Interim Technical Report

DIABLO CANYON UNIT 1
IDVP VERIFICATION OF CORRECTIVE ACTION
-Containment Building-
ITR #54, Revision 1

Docket No. 50-275
License No. DPR-76

INTERIM TECHNICAL REPORT
CONTAINMENT STRUCTURE

Figure 1
 Equipment Hatch Analytical Model - Isometric View (Reference 6)

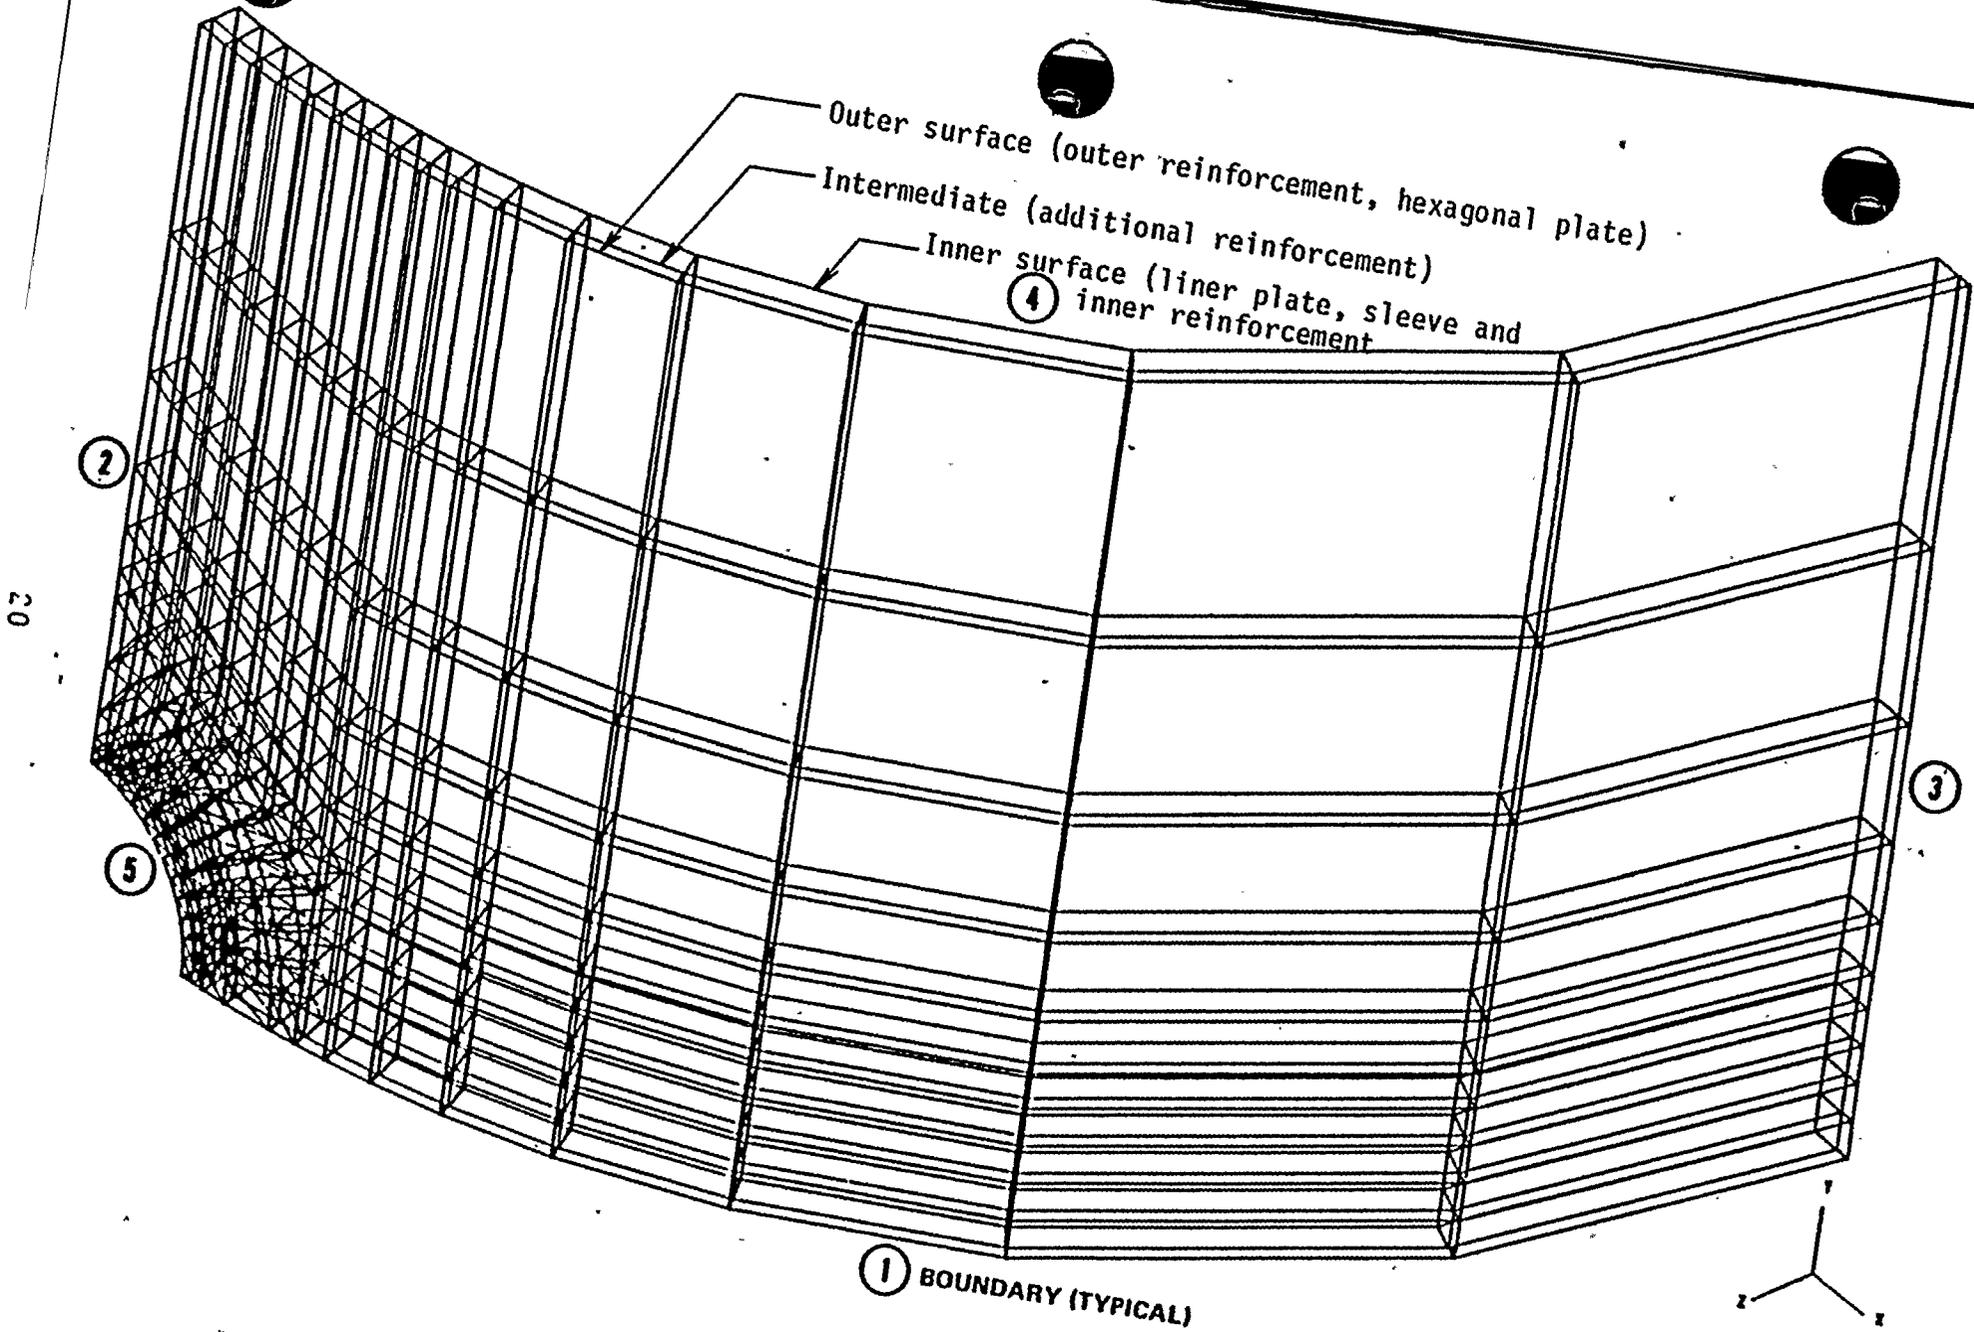
Hand calculations performed by the DCP indicated the need for a more sophisticated analysis. A 90-degree sector, 60-foot high three-dimensional model was assembled. A pictorial representation of the model is given in Figure 1. The finite element mesh consists of three parallel surfaces, shown in the figure, and connected by transverse beam elements.

Boundary conditions were provided based on the application of symmetrical or nonsymmetrical loads. These boundary conditions and locations are summarized in Table 1. For seismic induced overturning moment, the structure remains symmetrical about the y-z plane. The vertical boundary is not allowed to displace. For seismic induced shear loads, the shear deformation in the x-direction is symmetrical about the x-y plane at boundary 3, and antisymmetric about the y-z plane at boundary 2. The vertical displacement is constrained at all boundaries.

Selected stresses and isostress plots were presented by the DCP in the PGandE Phase I Final Report. Local yielding was noted in small areas of the hexagonal plate near the penetration sleeve. Computed stresses were stated to closely match values from strain gage measurements taken during the structural integrity test.

Figure 2
Polar Crane Rail Clip Anchorage System and Guide Strut Inner Box

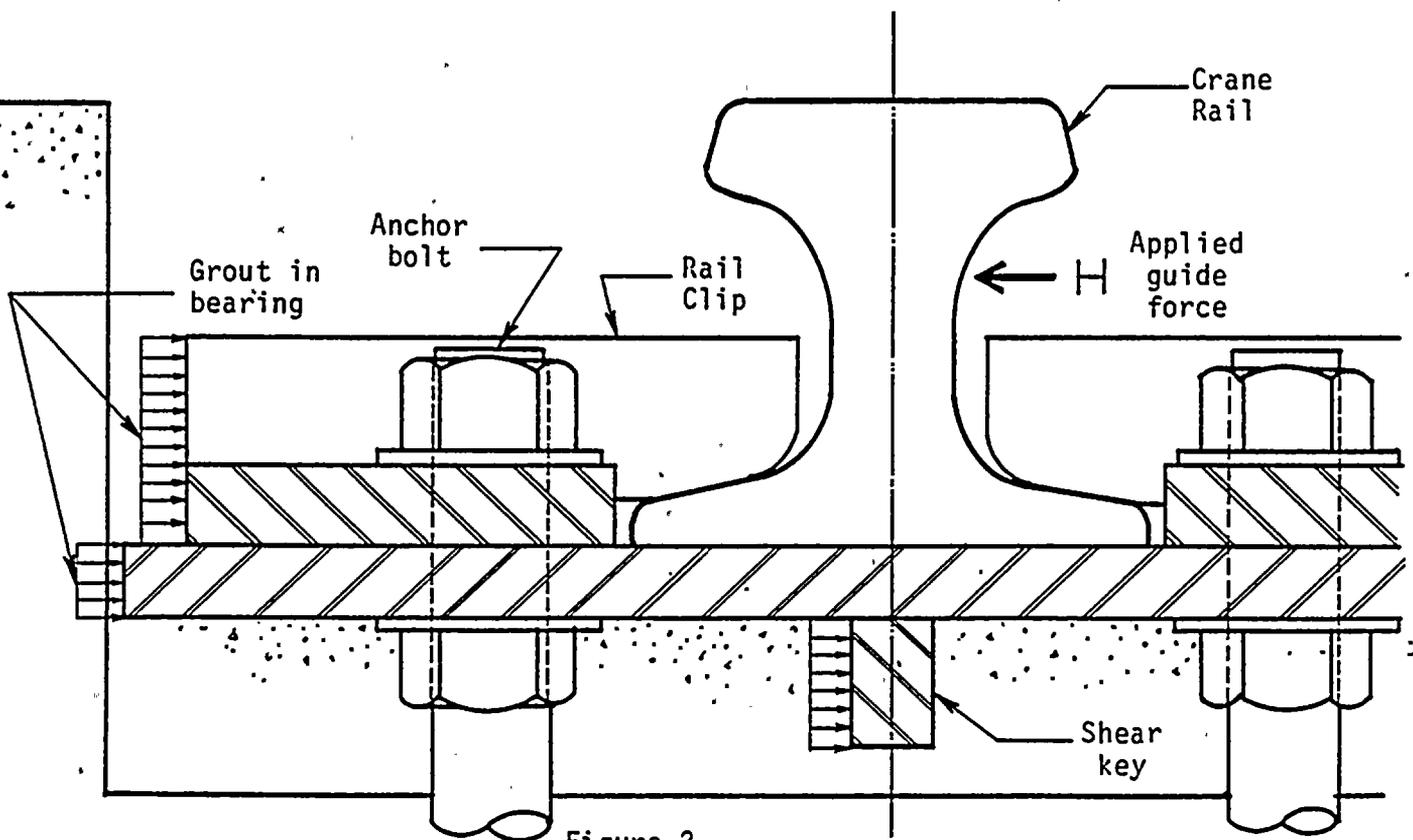
The rail clip anchorage system is illustrated in Figure 2. Applied loads and reaction components and surfaces are detailed.

The results of these computations for DCP Calculation #320C-2 were used in the polar crane guide strut analysis (Calculation #320C-4), where capacity versus demand comparisons were made. These comparisons show that the tensile capacity of the anchor bolts was properly computed and stated as controlling over the plastic moment capacity of the rail clip assembly. The IDVP verified the values as being acceptable. Appropriate consideration was given to the possible failure of the grout-bearing surface.

Figure 3
Polar Crane Guide Strut

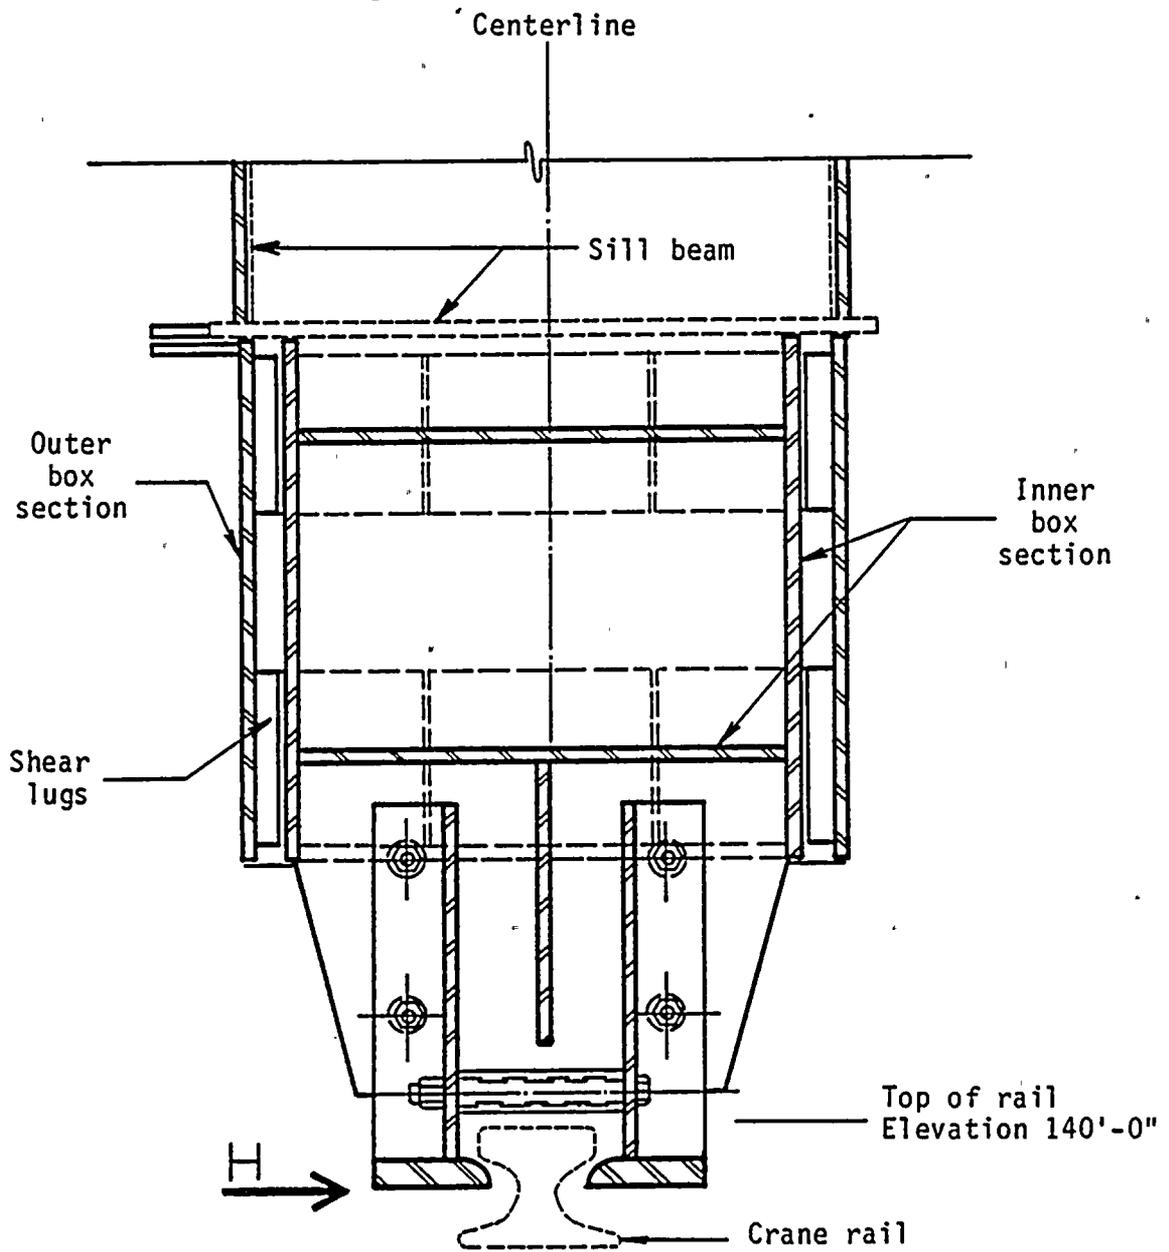
The structural components used to transfer the load are illustrated in Figures 2 and 3.

The DCP computed capacities considering shear and bearing in the rail web, and included the capacities for the rail anchorage system determined in Calculation #320C-2. Values are presented in Table 2.

The sill beam was analyzed and shown to safely transfer loads from the guide struts to the crane legs. The truck capacity was determined with respect to out-of-plane bending of the side plates and shear on the wheel rims.

Bending and shear (torsional and direct) stresses were properly computed for the sill beam section with the result that both combined and principal stresses were less than allowables. The truck capacity calculations considering bending in the side plates and shear in the wheel rim were also acceptable.
